Date: 20 April 2022

Subject: ADDENDUM NO. 1

Project: A NEW SECURITY & SERVICES TRAINING FACILITY

Job #: ANG# BRKR009063 / SSL# 12072

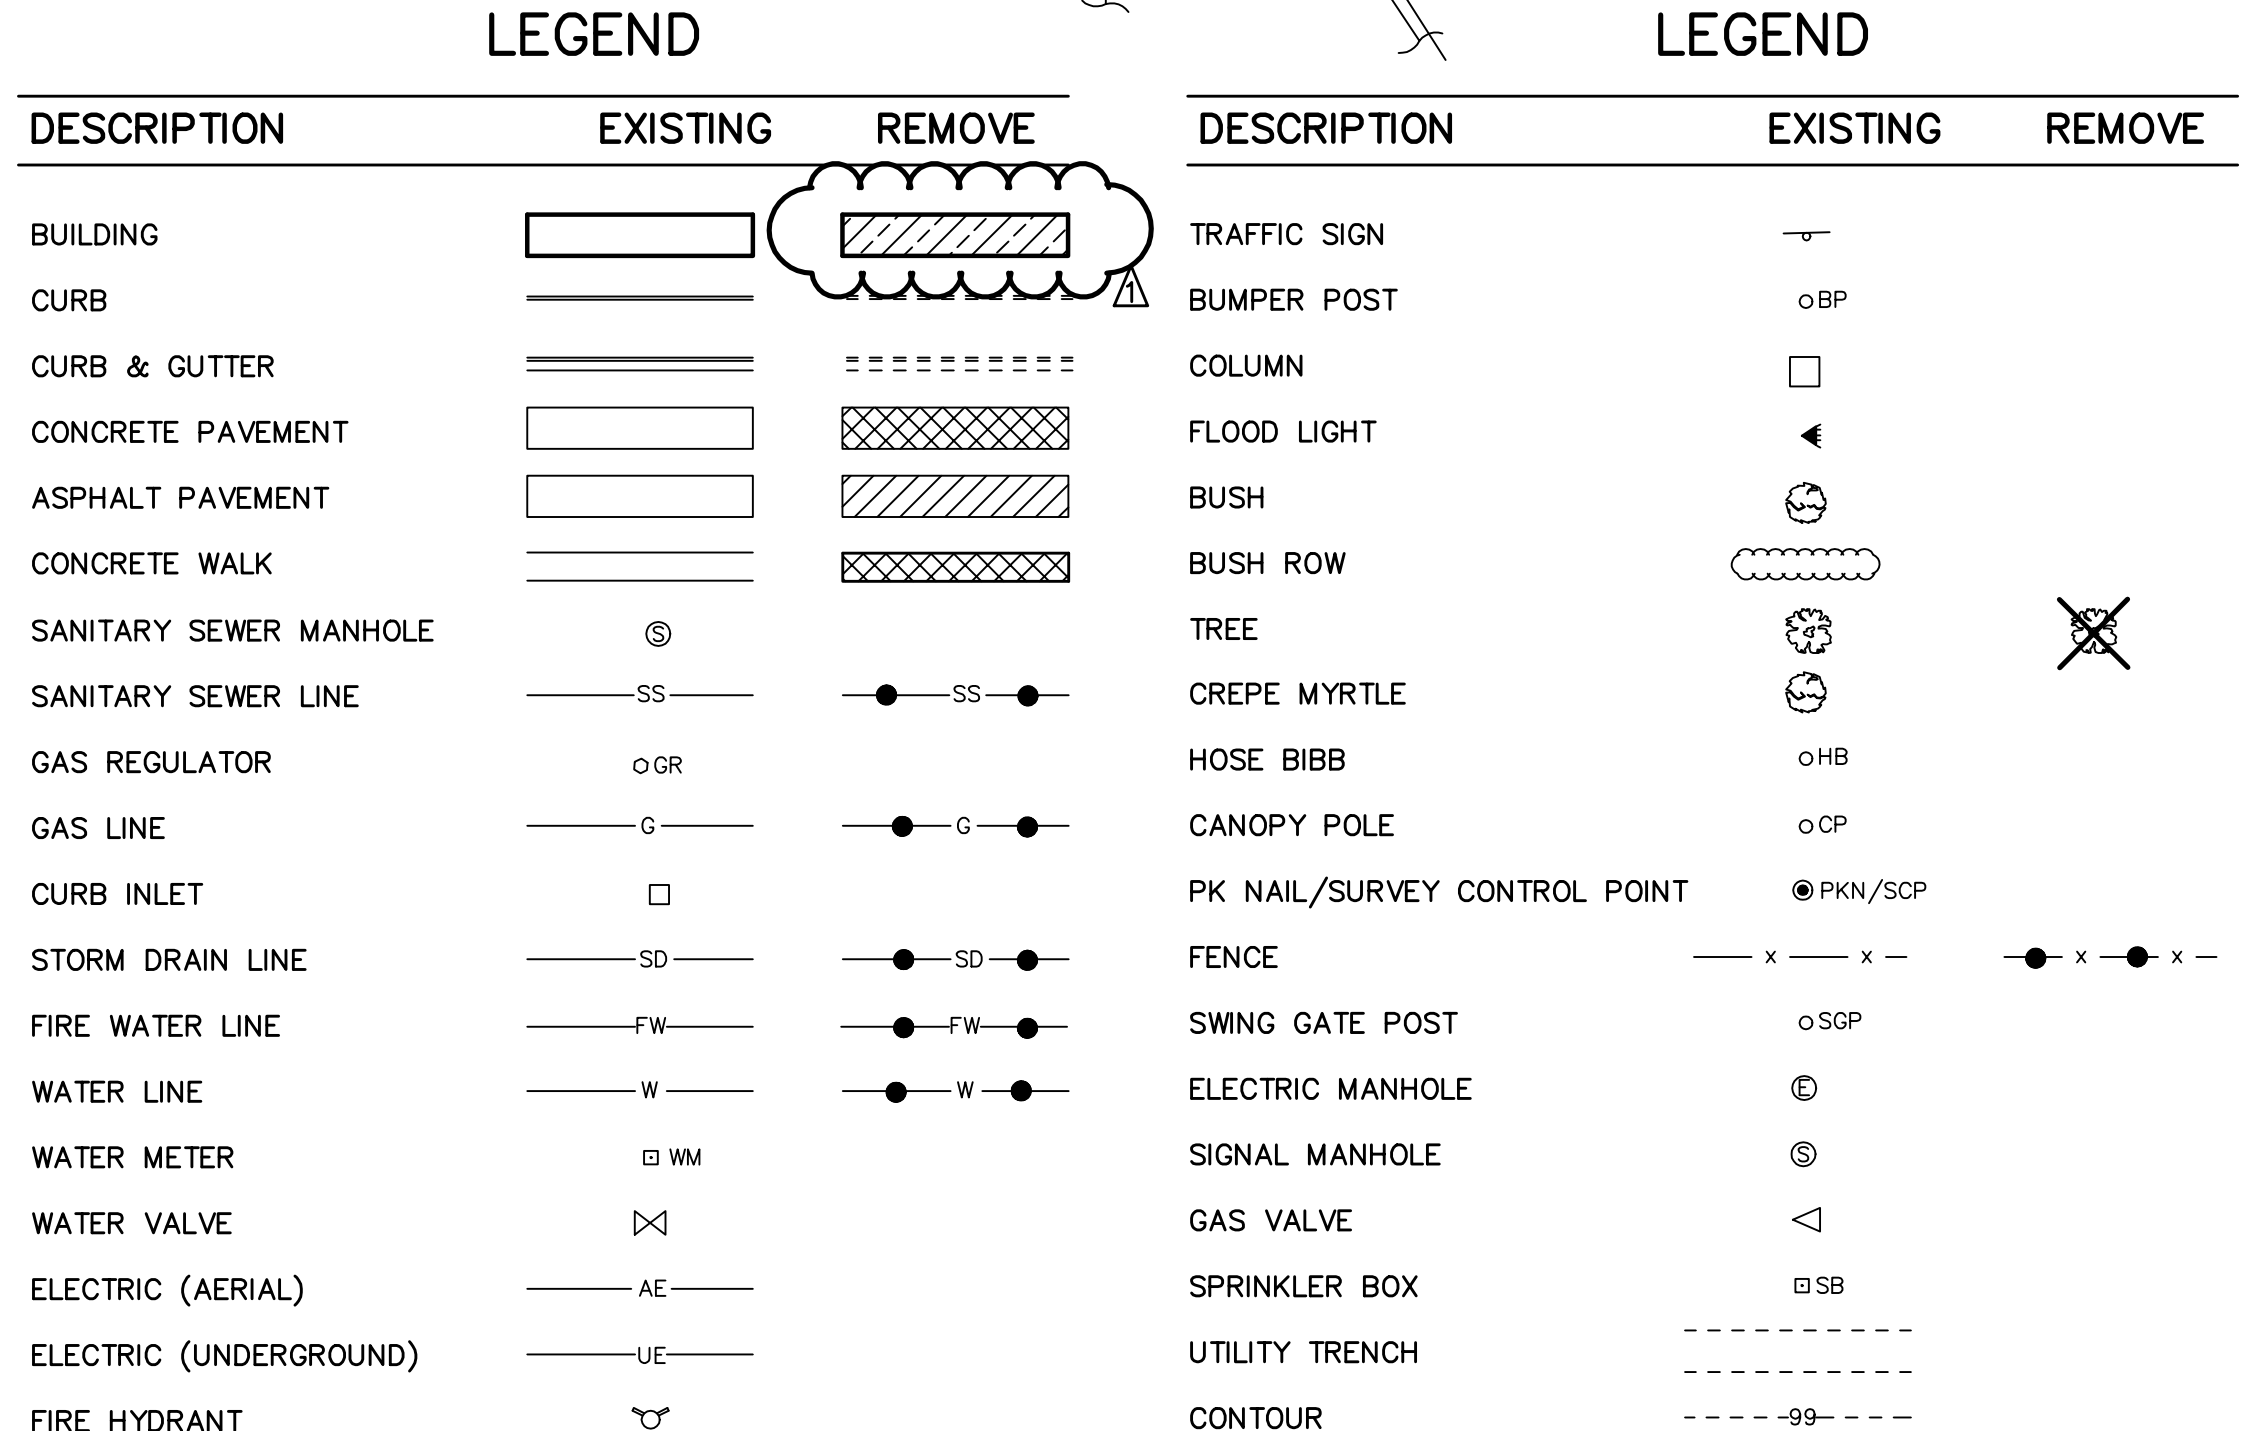
Item No. 1: Refer to drawings. Delete drawing sheet C2.1 “Site Demolition Plan (BASE BID) and drawing sheet C2.1A “Site Demolition Plan (BID OPTION) and replace them with the attached drawing sheets C2.1 and C2.1A with a revised date of 4/20/222. Note that revisions are included within clouded areas on plan.

Clarification: Demolition of Buildings 204, 205, and 214 shall be included within the base bid. Demolition of Building 202 shall be included within the scope of Bid Option #3.

CONTRACTOR SHALL FIELD DETERMINE LOCATION AND ELEVATION OF EXISTING AVIATION FUEL LINES PRIOR TO PERFORMING ANY WORK IN THE AREA OF THE LINES. THESE LINES SHALL NOT BE DISTURBED UNDER ANY CONDITIONS.

3. OMITTED.
4. REMOVE AND REPLACE ASPHALT IN THIS AREA AS REQUIRED TO INSTALL NEW RETAINING WALL FOOTING/WATER LINE.

NEW BUILDING LINES SHOWN ON CIVIL PLANS ARE FOR VISUAL PURPOSE ONLY AND SHOULD NOT BE USED IN ANYWAY TO LAYOUT NEW BUILDING. FOR THIS YOU SHOULD REFER TO THE FOUNDATION PLAN AND OTHER ARCHITECTURAL PLANS.
